Model: AT-C1 Paper feed unit		Date: 25-Apr-07	No.: RB801001
Subject: LCT JAM		Prepared by: T.Kiyohara	
From: 1st Tech. Support Sec. Service Support Dept.			
Classification:	<input checked="" type="checkbox"/> Troubleshooting <input type="checkbox"/> Mechanical <input type="checkbox"/> Paper path <input type="checkbox"/> Product Safety	<input type="checkbox"/> Part information <input type="checkbox"/> Electrical <input type="checkbox"/> Transmit/receive <input type="checkbox"/> Other ()	<input type="checkbox"/> Action required <input type="checkbox"/> Service manual revision <input type="checkbox"/> Retrofit information

Model: PB3010		Date: 19-Aug-09	No.: RB801002a
Subject: Parts Information		Prepared by: M. Kumagai	
From: 2nd Tech Support Sec. Service Support Dept.			
Classification:	<input type="checkbox"/> Troubleshooting <input checked="" type="checkbox"/> Part information <input type="checkbox"/> Action required <input type="checkbox"/> Mechanical <input type="checkbox"/> Electrical <input type="checkbox"/> Service manual revision <input type="checkbox"/> Paper path <input type="checkbox"/> Transmit/receive <input type="checkbox"/> Retrofit information <input type="checkbox"/>

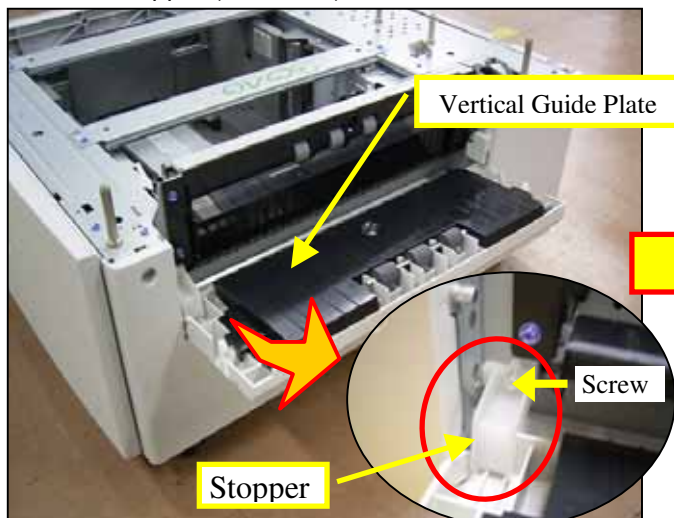
A paper feed jam occurs with the LCT unit at installation.

There is a small scratch in the separation guide plate of the LCT unit.

Attach two Mylars(P/N:B2249500) to the separation guide plate (**see procedure below**).
